Addendum No. 2
Merrill Virtual Learning Center
Berrien Springs Public Schools

29 December 2020

This addendum forms a part of the Contract Documents and modifies the original Bidding Documents (PROJECT MANUAL dated **07 December 2020**). Please acknowledge receipt of this Addendum when submitting your bid. This Addendum has been distributed to the plan holders of record only. It is the bidder's responsibility to distribute Addendum information to subcontractors and material suppliers. This Addendum reflects modifications from the Owner, Architect, and Bidders.

E1.0

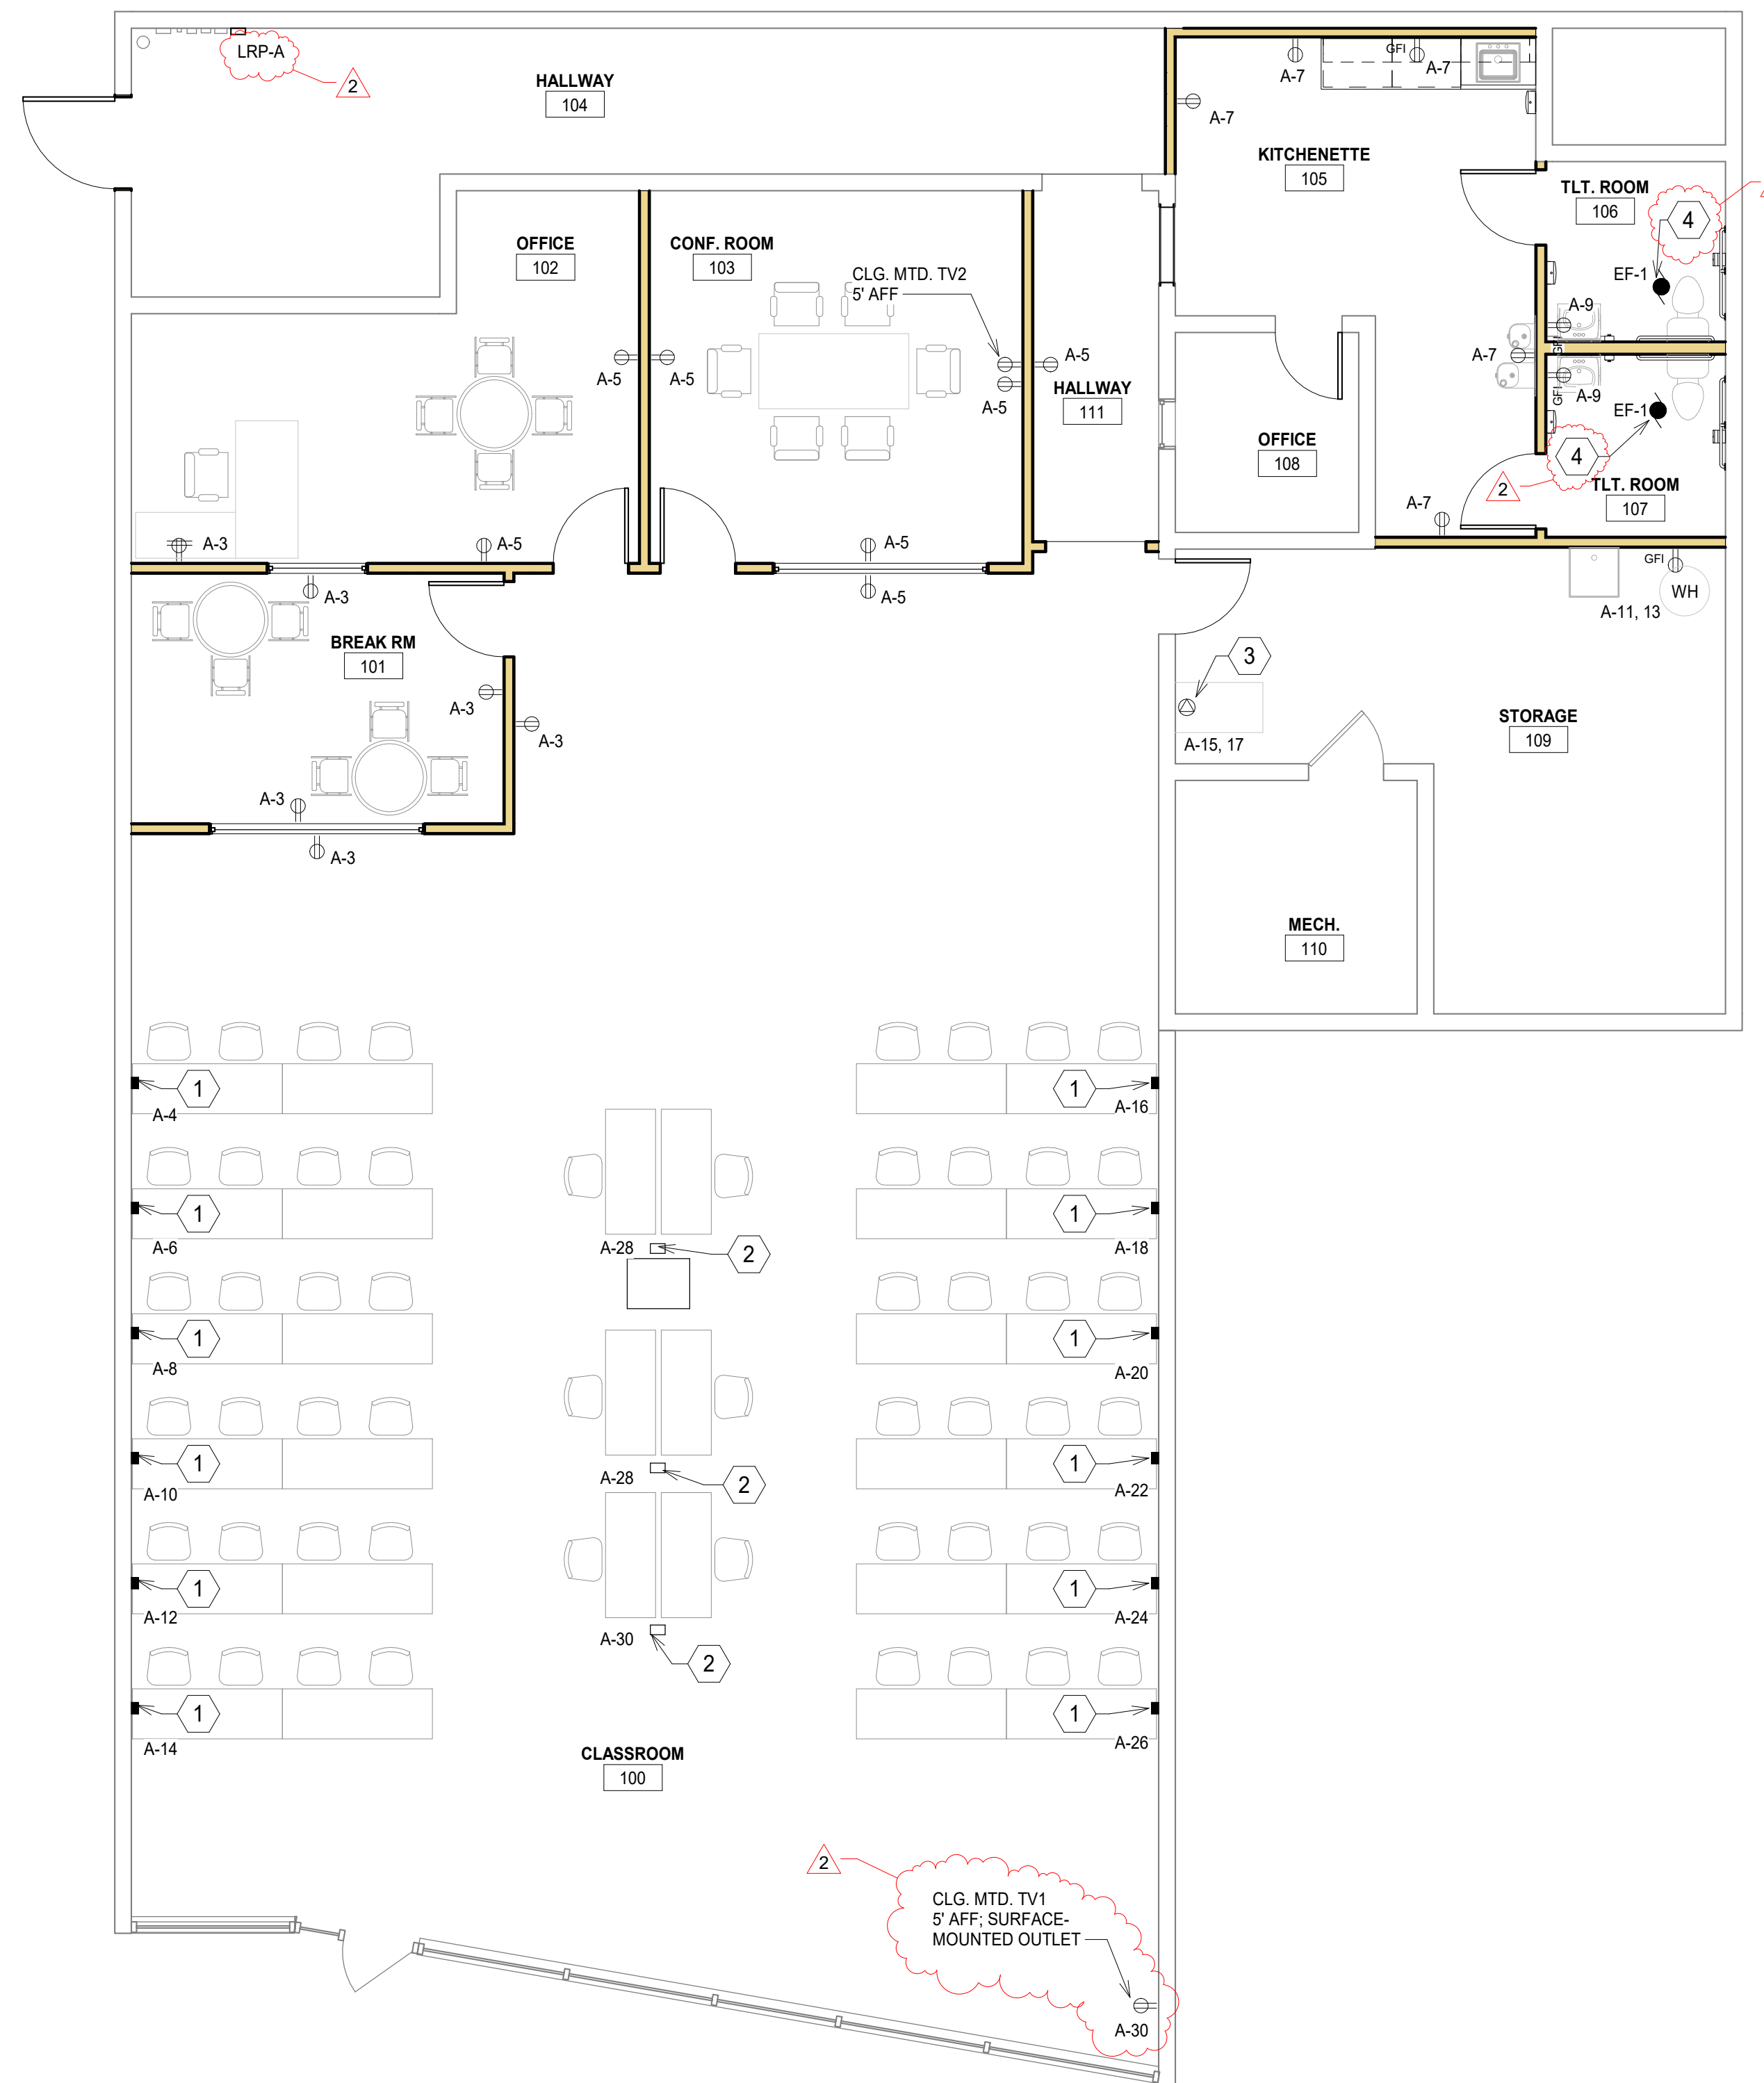
3. E1.0 Electrical Power Plan:
 - a. The electrical panel box should be labeled LRP-A as shown on the riser diagram, sheet A2.0.
 - b. The electrical outlet for the wall-mounted TV in Classroom 100 should be surface mounted.

- c. Power Key Note #4 should appear in Toilet Rooms 106 and 107 at the exhaust fans (EF-1).
 - d. Classroom 100 power poles should be aluminum and divided to separate power and low voltage wiring: Hubbell/Bryant or equal. Electrical contractor shall provide and install power poles and run electrical wiring. Low voltage wiring will be installed by others.

- e. Power/data raceway for Classroom 100 walls shall be Wiremold 4000 Series, provided and installed by electrical contractor. Low voltage wiring will be installed by others.

- f. Electrical contractor is responsible for installing flexible conduit and power/data boxes at computer tables. Owner is responsible for running data cable to tables. Table mfr./model: National Business Furniture, model number 46289 (nationalbusinessfurniture.com)
